# NORTH TEXAS MUNICIPAL WATER DISTRICT

## LAKE SIDE INTERCEPTOR REPLACEMENT

PROJECT NO. SRWWPCF 07-1(102)

### CONFORMED SET

**PLAN AND PROFILE**  
 STA. 64+00 TO STA. 69+00

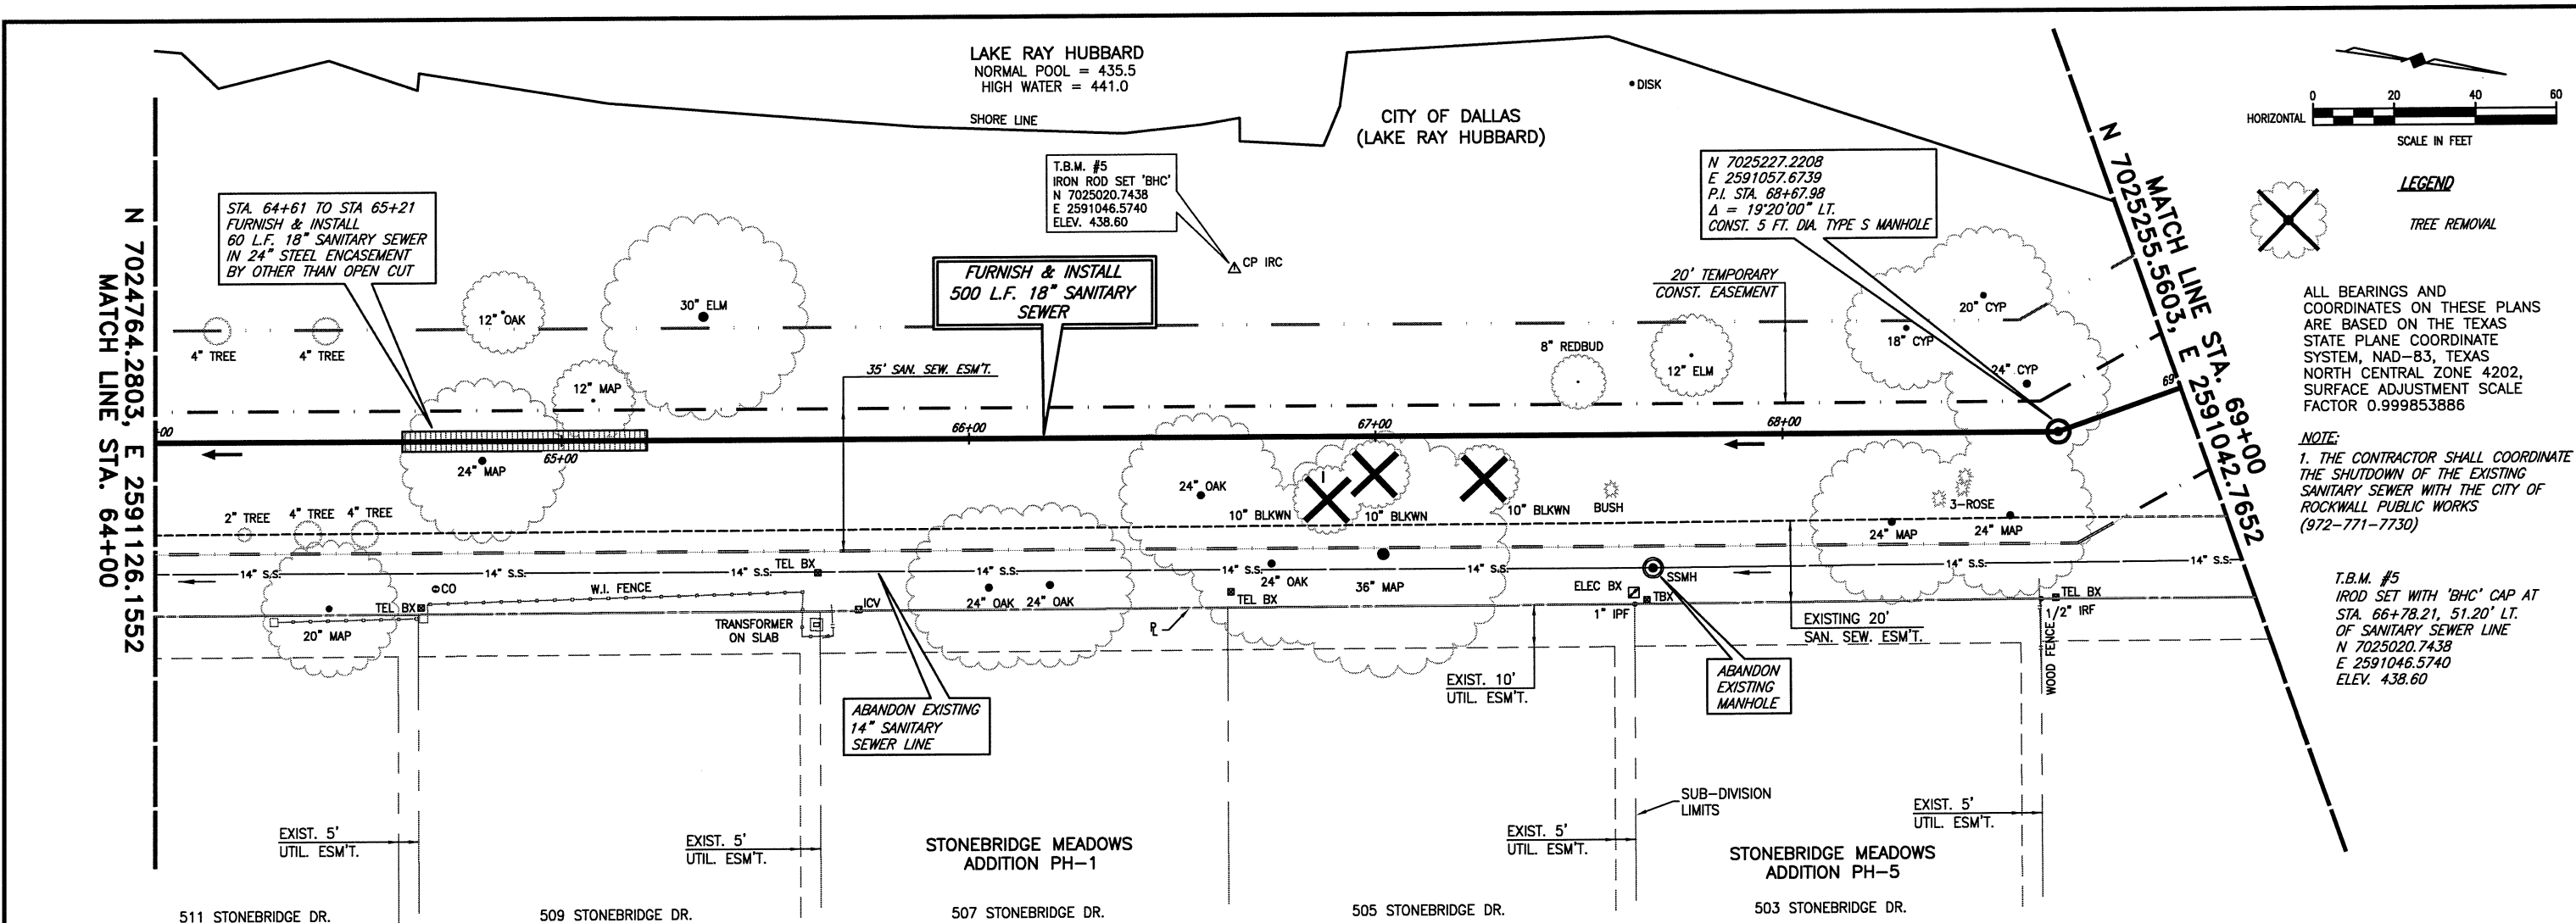
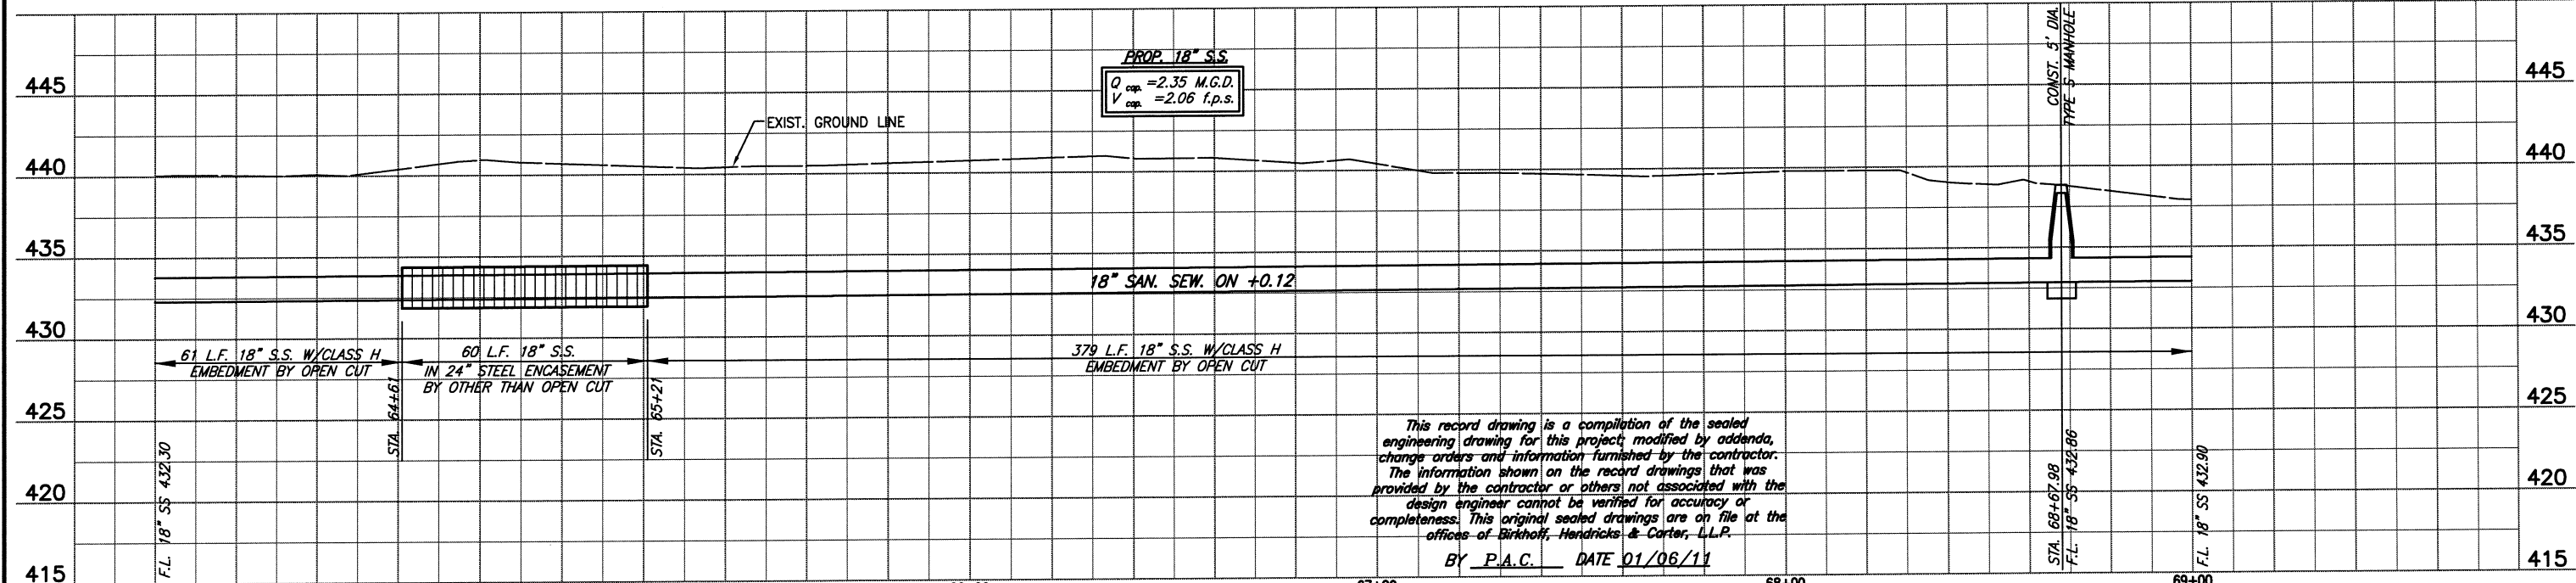
CHANGE ORDER NO.1 2/12/09 - REVISED BORE LOCATIONS & ENCASEMENT
FIELD CHANGE NO.4 6/29/09 - REVISED VERTICAL ALIGNMENT

**NORTH TEXAS MUNICIPAL WATER DISTRICT**  
 LAKESIDE INTERCEPTOR REPLACEMENT  
 PLAN AND PROFILE  
 STA. 69+00 TO STA. 74+00

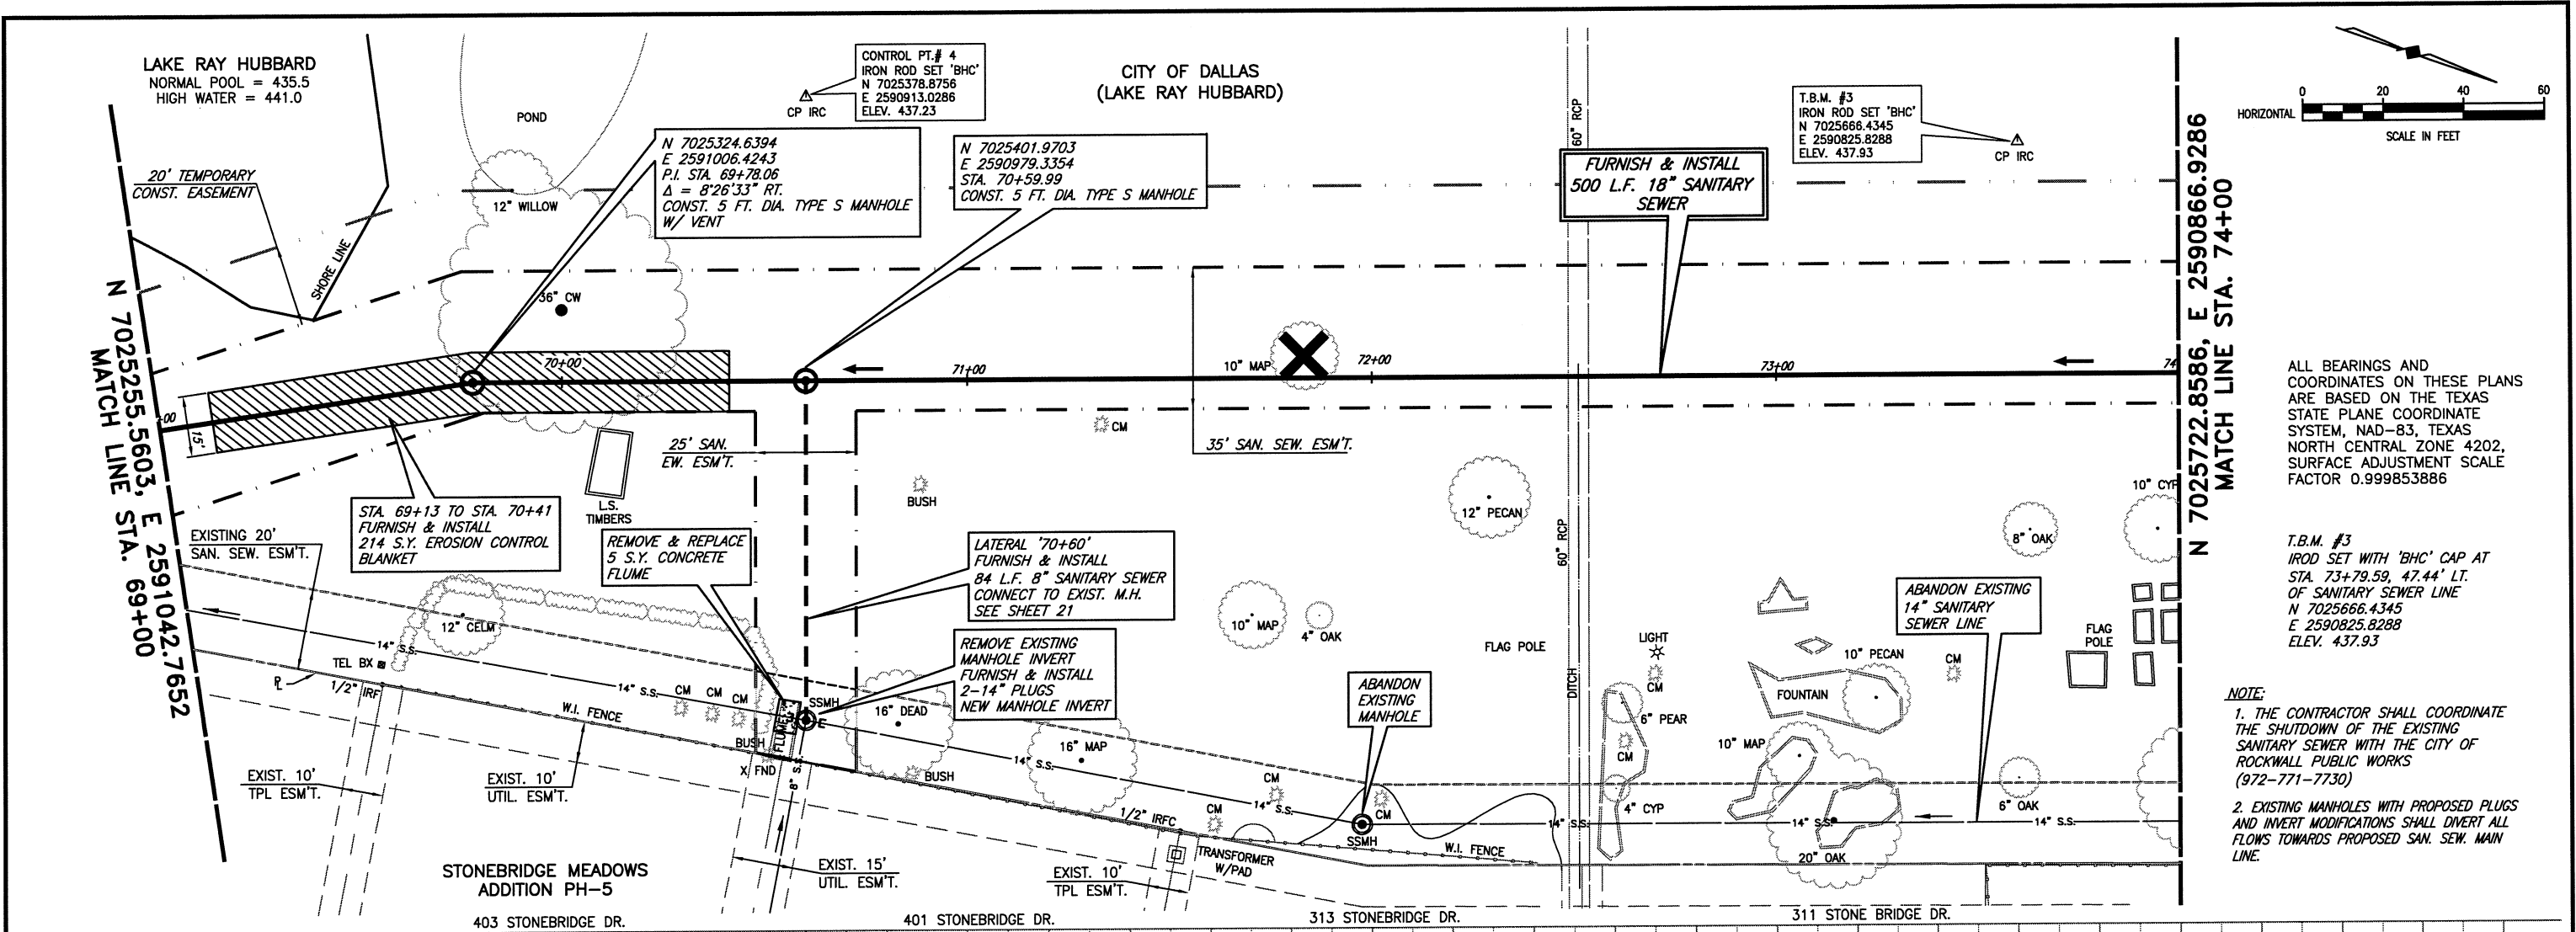
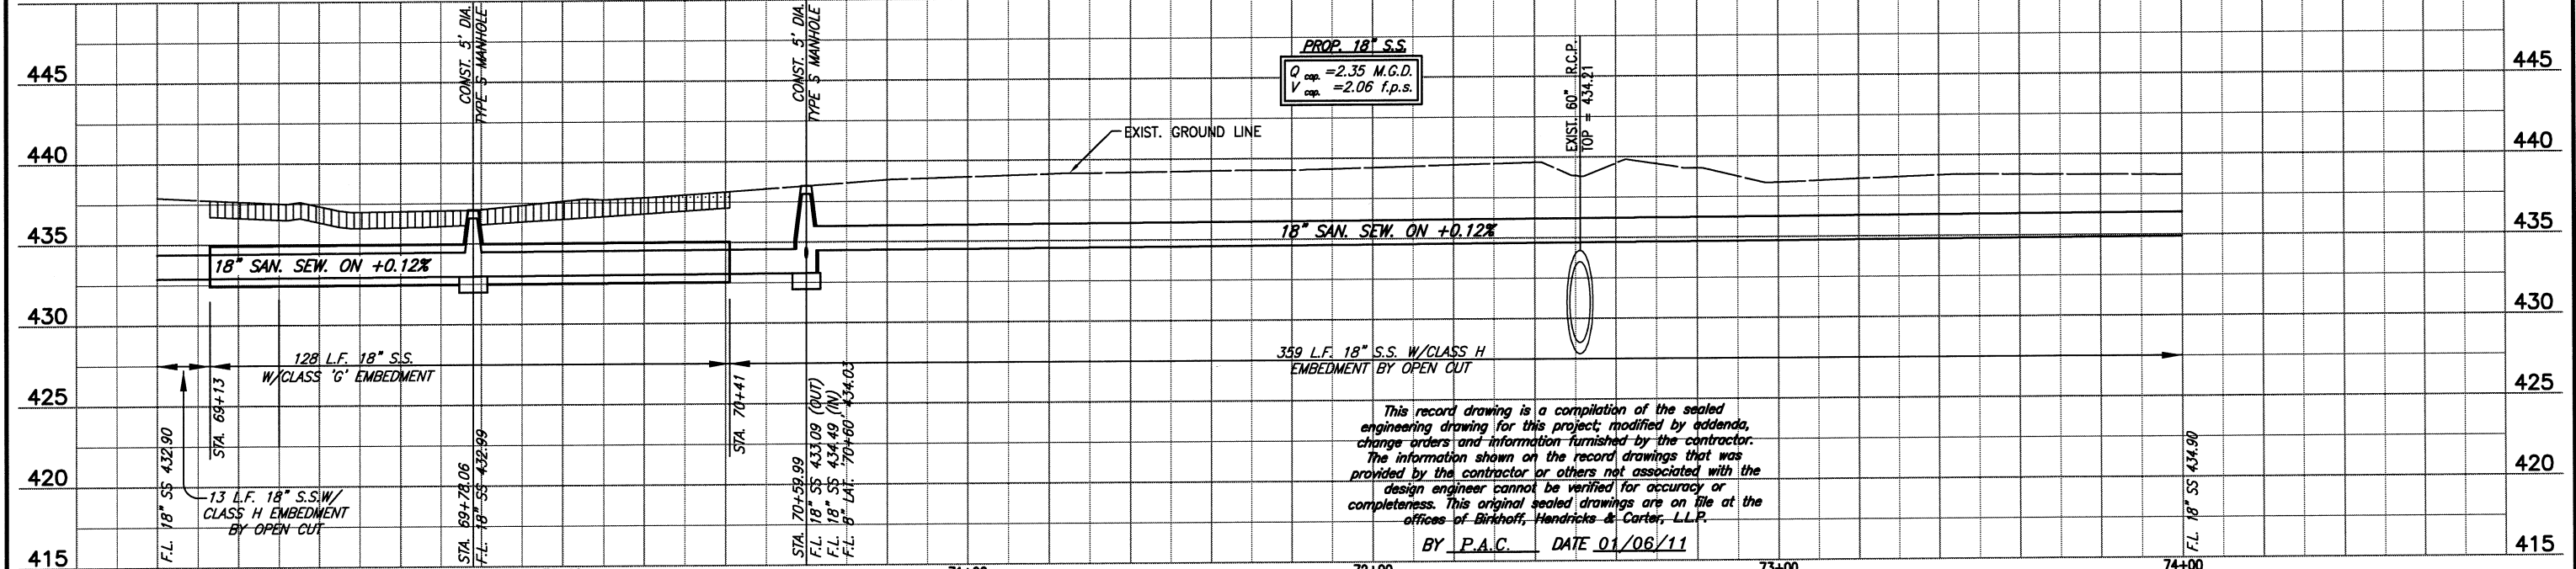
FIELD CHANGE NO.2 2/12/09 - REVISED TREE REMOVAL LOCATIONS
CHANGE ORDER NO.1 2/12/09 - REVISED BORE LOCATIONS & ENCASEMENT
FIELD CHANGE NO.4 6/29/09 - REVISED VERTICAL ALIGNMENT
